Cadia Valley Operations MOD 15 – Submission by Bruce Reynolds

Please find below my submission on Modification 15 for Cadia Valley Operations.

Seed Figure 1. Green area in the bottom left of map is currently untouched BASL but will be consumed by the tailings dam wall.

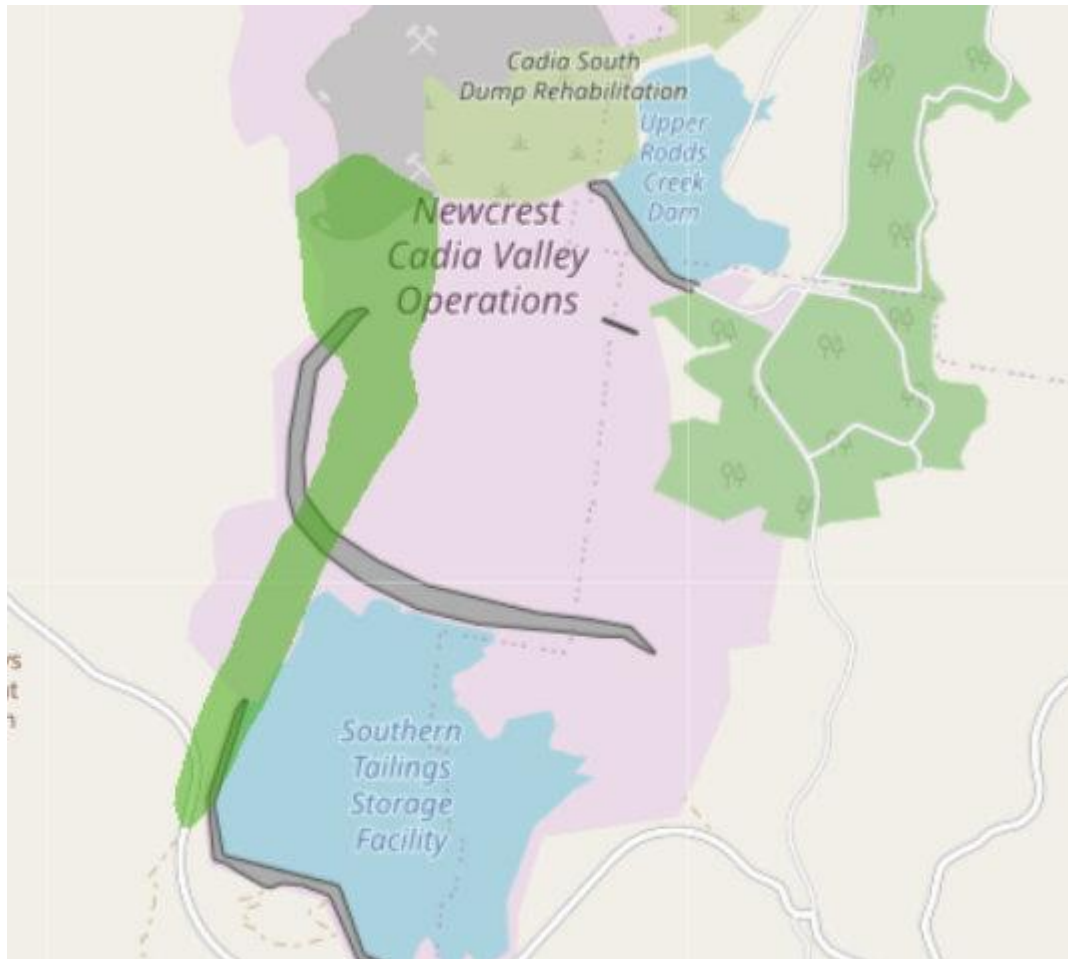
The extension of the southern tailings dam wall to the west will used some Strategic Agricultural Land- Biophysical (BSAL) as listed on the NSW Government SEED website. There

is no mention of this further loss of BASL land in the modification. Given how scarce this land is within NSW, there should be some form of assistance for neighbouring landholders to increase productivity. The mines tailings dams and operations have already consumed some BASL land. See figure 1.
